ANADROMOUS WATERS CATALOG/ATLAS
CORRECTION FORM

Map: Tyonek D-4

Water Body Number: 247-41-10200-2053-3205-4053-5009
 247-41-10200-2053-3205-4009-5025

Nomination Number: 10-941

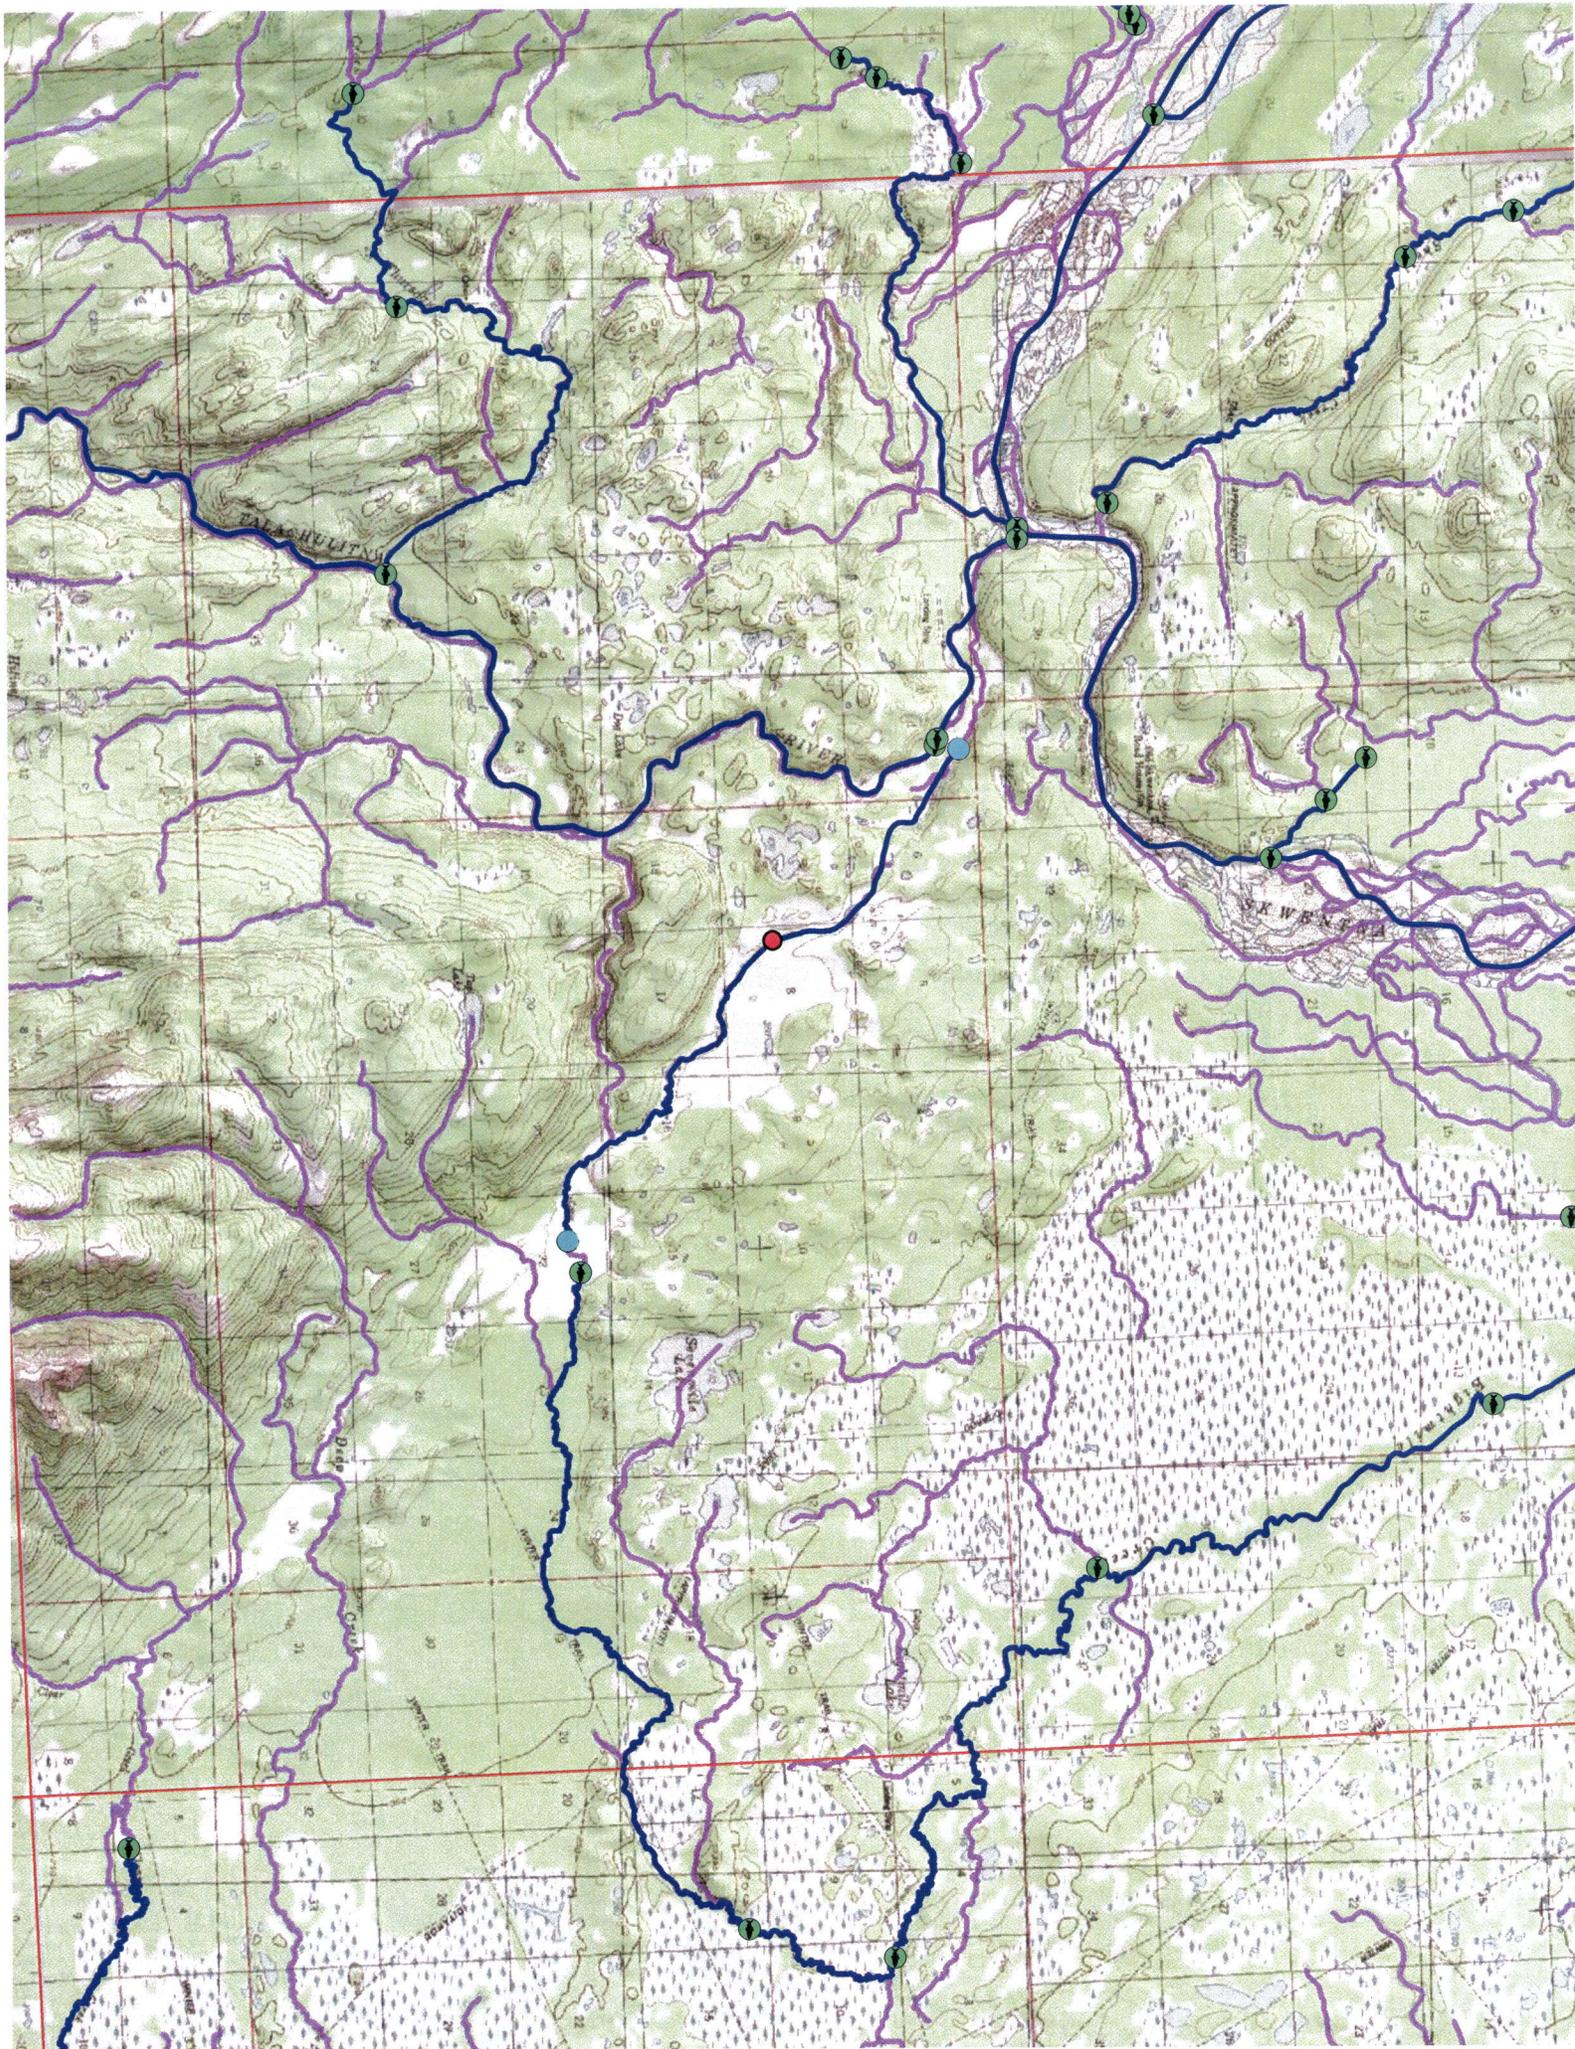
Describe Change(s): Add -5009 to end of -5025

make single stream w/ending number -5025

J,
I think Mark is right. -5009 appears to flow into -5025, and the whole system drains to Eightmile Creek. In my opinion, the entire length of -5009 should be switched to drain into -5025, and the 2 streams should be joined into a single AWC stream. Zooming way in, -5009 does not appear to have a confluence with the Talachulitna at all, but it appears to be continuously connected to -5025.

Hello,
247-41-10200-2053-3205-4053-5009 appears to flow into 247-41-10200-2053-3205-4009-5025. If you look at google earth, the beaver ponds show the water flowing the other way, at least for a majority of its length. I can't be sure exactly where it starts flowing to the Talachulitna River. Just a heads up
